STORM WATER REPORT

Cobey Creek
Mixed Use Development
Lee's Summit, MO

1. Original Storm Report-May 22, 2018
2. Addendum 1- July 1, 2019- Effective Height and Energy Dissipation additions to North Pond
3. Addendum 2- August 3, 2020- Updated South Pond Outlet Structure-Pond Pack Print out.
4. Addendum 3- October 8, 2020- Approved Outlet Structure Geometric Changes from Circular to Square and Rectangular

Addendum 3
Cobey Creek
Mixed Use Development
Lee's Summit, MO

HY-8 Energy Dissipation Report

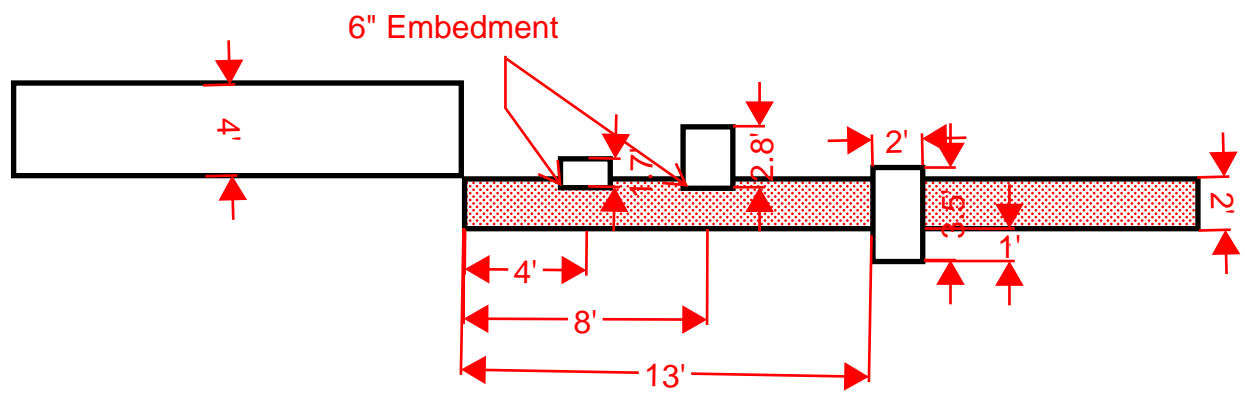
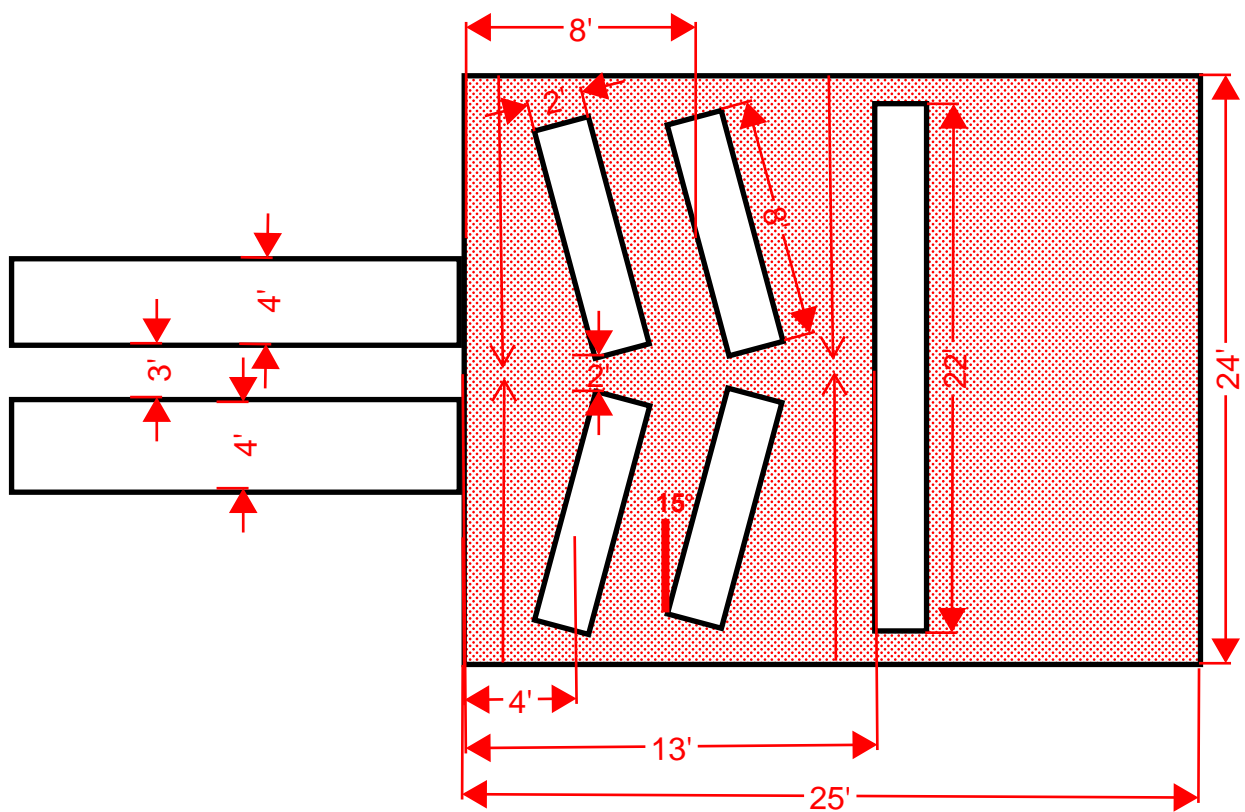
Additional energy dissipation has been added to the outlet structure at the request of the City of Lee's Summit. The outlet rip rap pad is fitted with a Contra Costa Design from HEC 14. The design details are included in the plans. The original 100-year outlet velocity is ~12.0 ft/s and the proposed 100-year outlet velocity is expected to be ~8.7 ft/s. Calculations are included in this Addendum.

STREET AND STORM SEWER PLANS
SOUTH DETENTION BASIN
OUTLET STRUCTURE
COBEY CREEK FIRST PLAT
PHASE I
CITY OF LEES SUMMIT, JACKSON COUNTY, MISSOURI

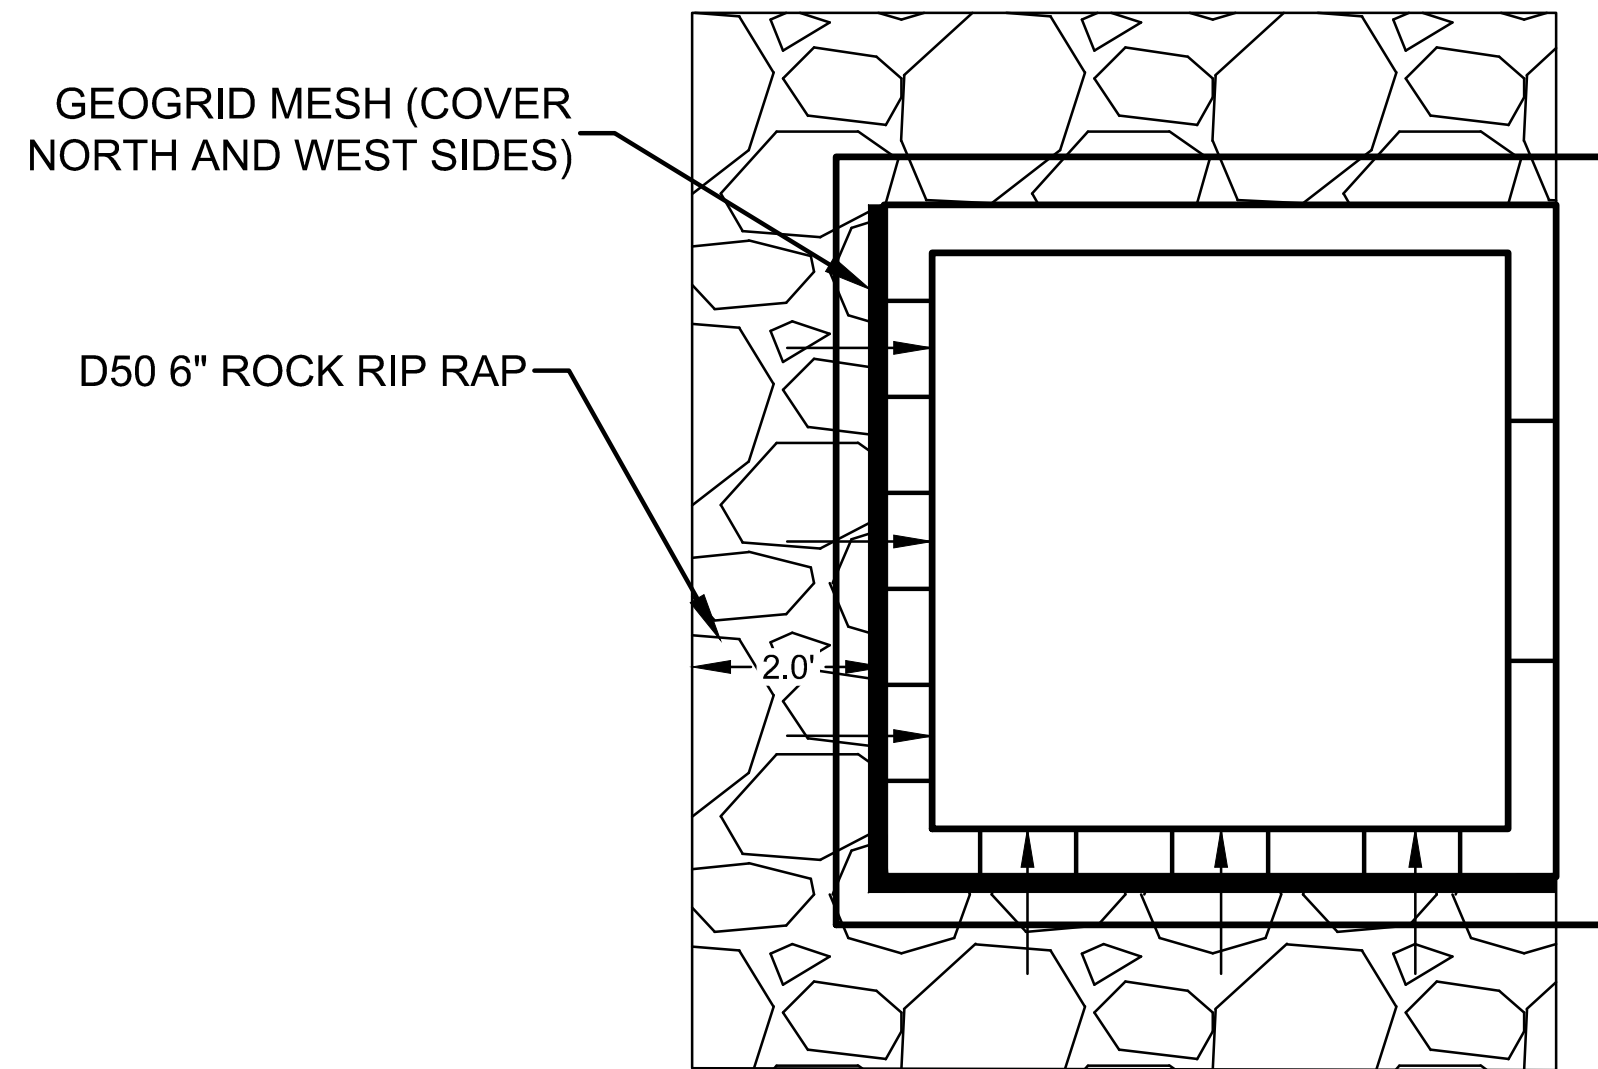
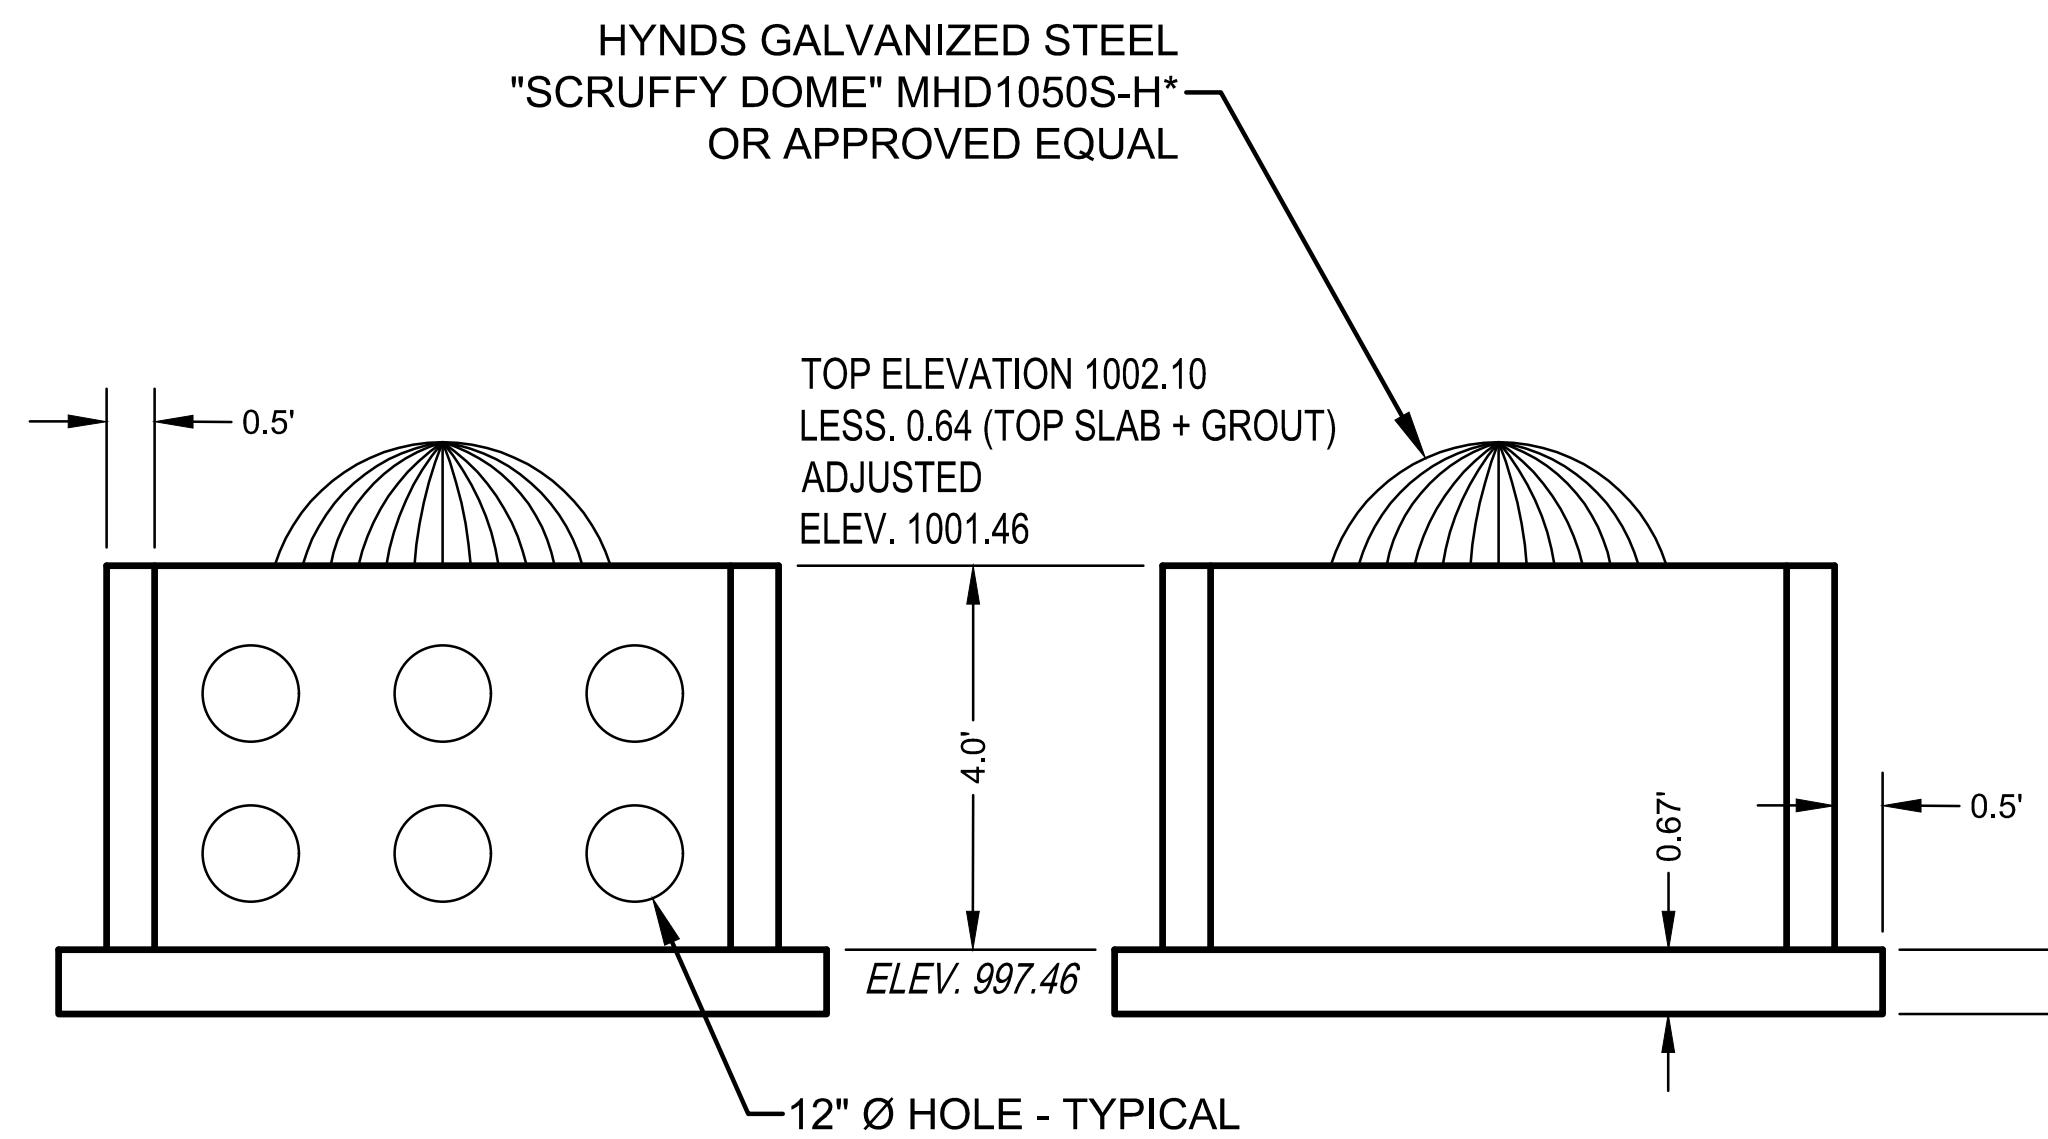
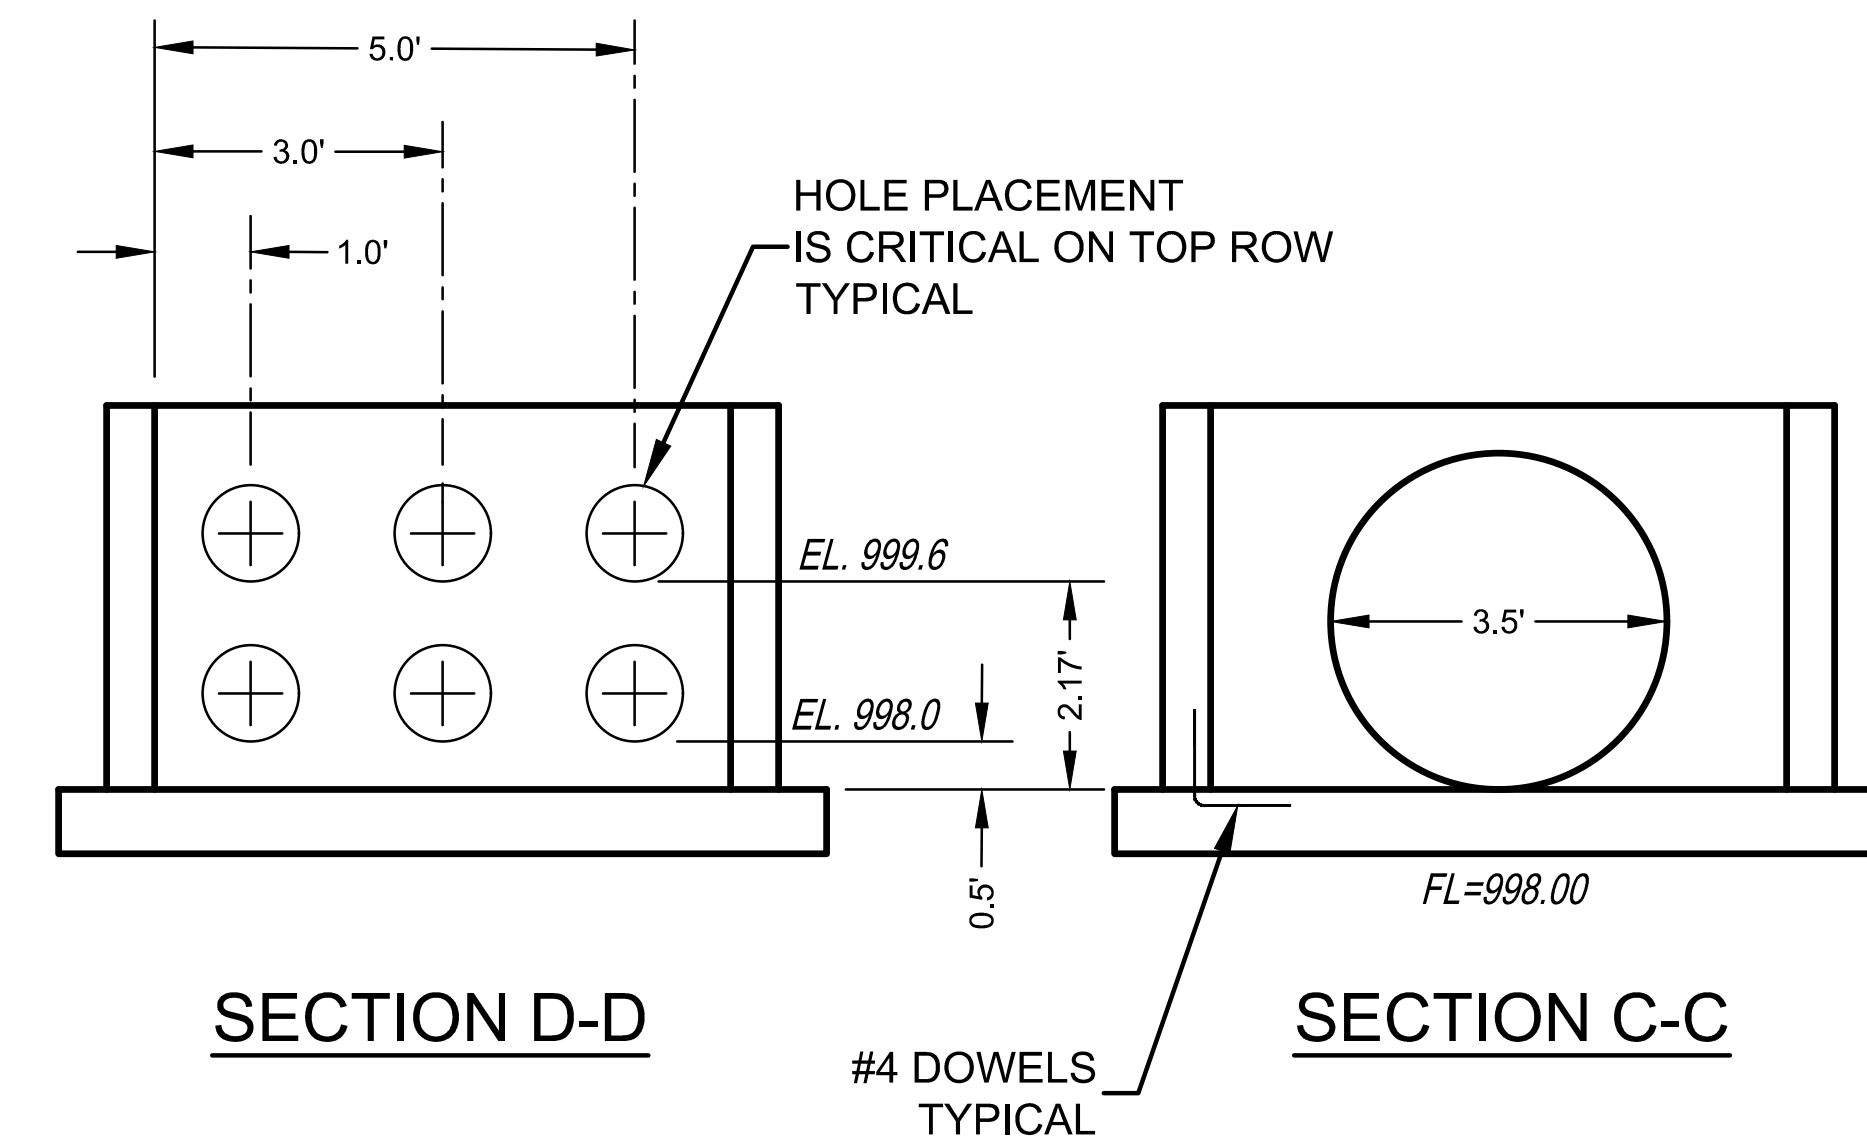
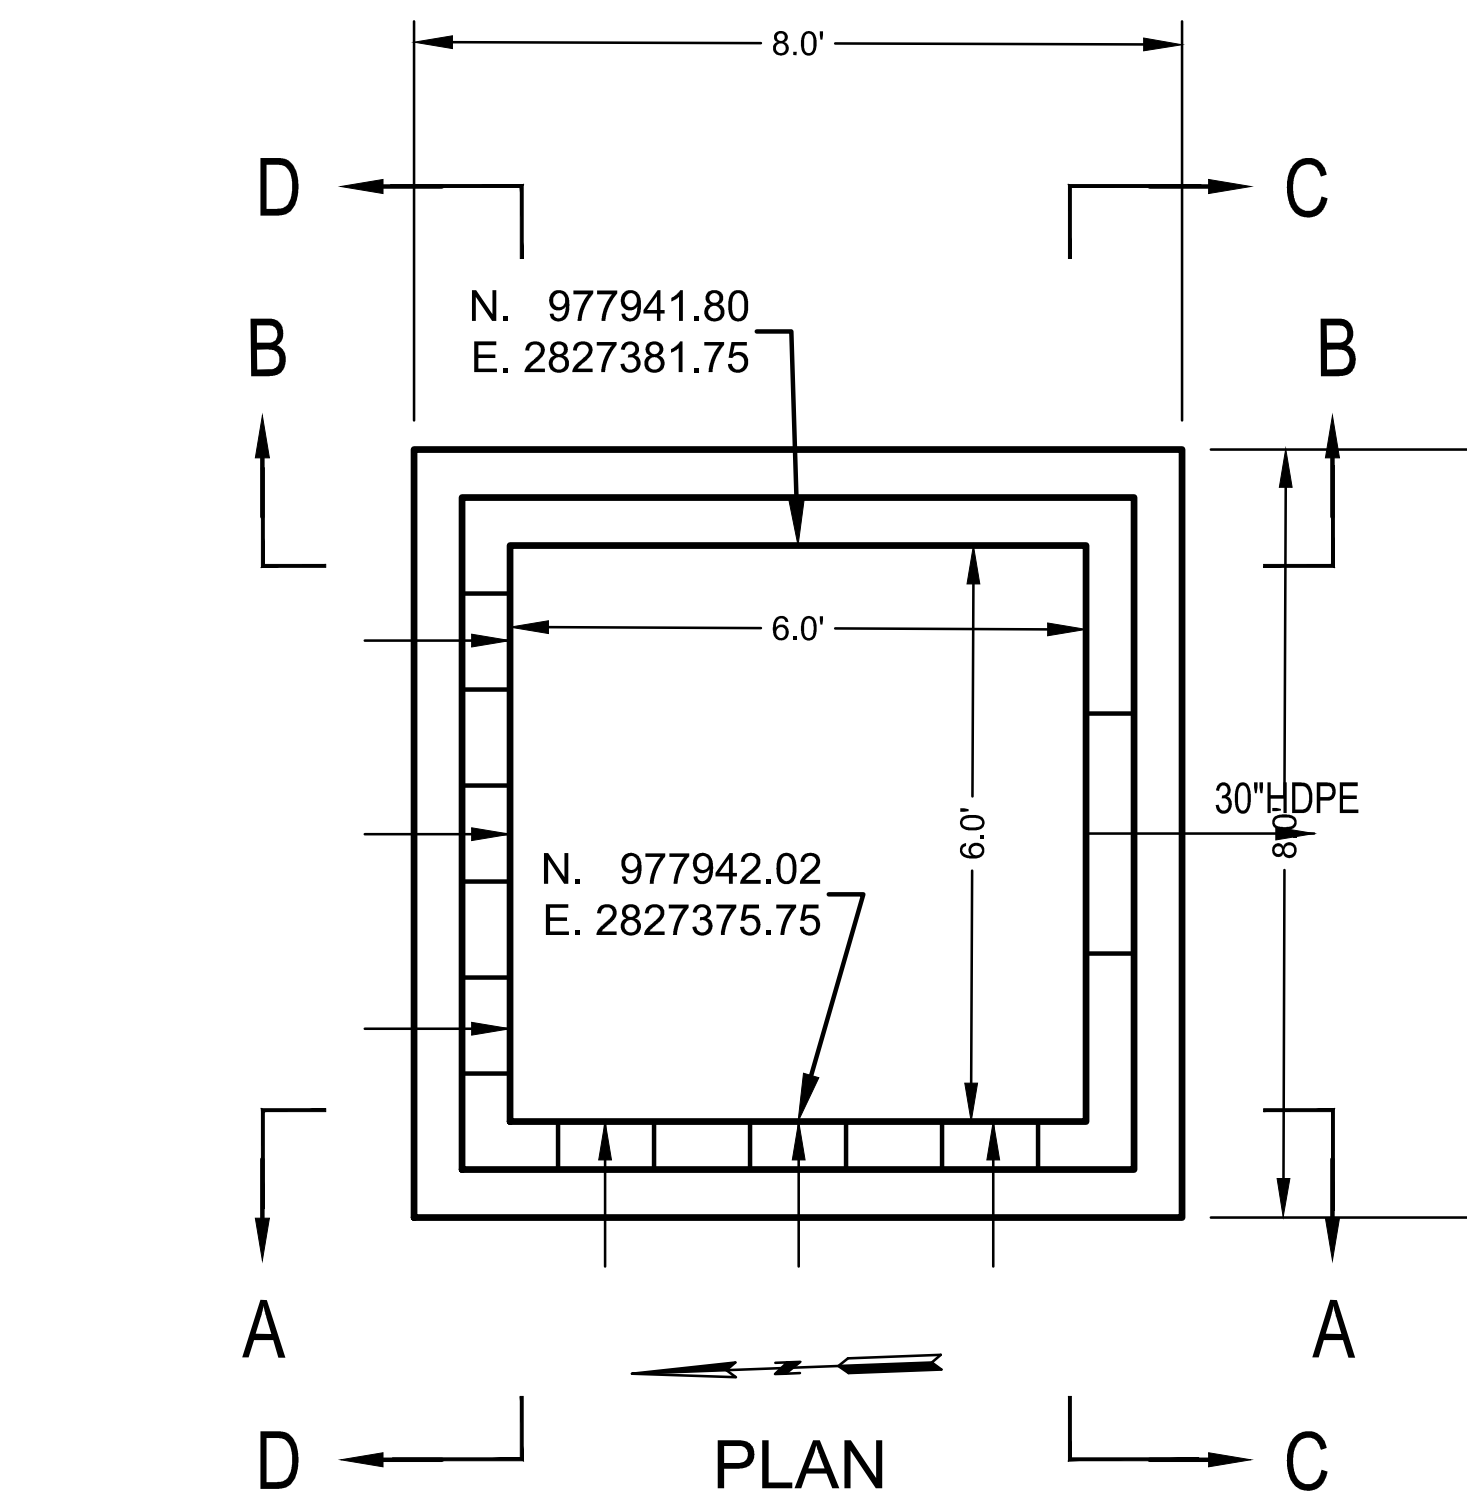
This addendum to the final storm report for Cobey Creek, Phase 1, is prepared to address the updating of the Pond Pack information for the south pond outlet structure. The attached Pondpack print out addresses the flow characteristics associated with six- 12inch diameter holes shown on the new square outlet structure detail, also attached.

The structure was changed to square from a circular manhole due to the unavailability of the manhole in a 6 foot diameter, as designed and approved in the original plans. The Pond pack information is provided as confirmation that original release orifices (12" holes) on the circular manhole when placed on the square version, shows no changes to the hydraulic function of the outlet structure within the pond.
